TfNSW reference: REN25/00172/002

Your reference: SSD-60598738 (PAE-112216988)

**SSD-60598738, Lake Lyell Pumped Hydro Energy Storage, Sir Thomas Mitchell Drive, South Bowenfels;
Response to Environmental Impact Statement**

Figure 2: Vehicle chassis on raised medians and kerb (indicated with red ovals) at Stewart St / Durham St. Source: Pinch Point 12, OSOM Route Study

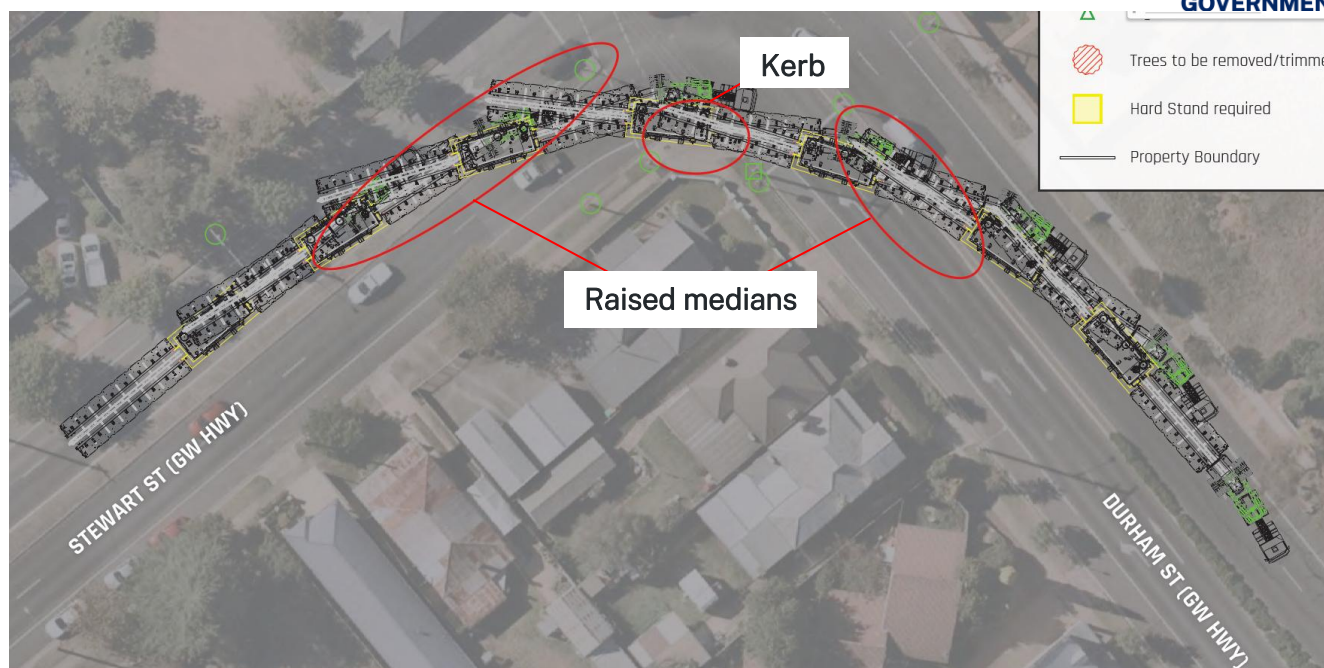
The swept paths provided indicate that the OSOM will traverse medians, kerbs and shoulders on State roads. Strategic designs for median / pavement strengthening are to be provided within a revised TIA or identify alternate mitigation measures such as a change to routes, contraflow or a change to the laden high-risk vehicle configuration.

Please refer to the Figures below for examples of where infrastructure has been traversed. Note that these examples do not encompass all such instances and it is the Applicant's responsibility to ensure all traversals have been addressed.
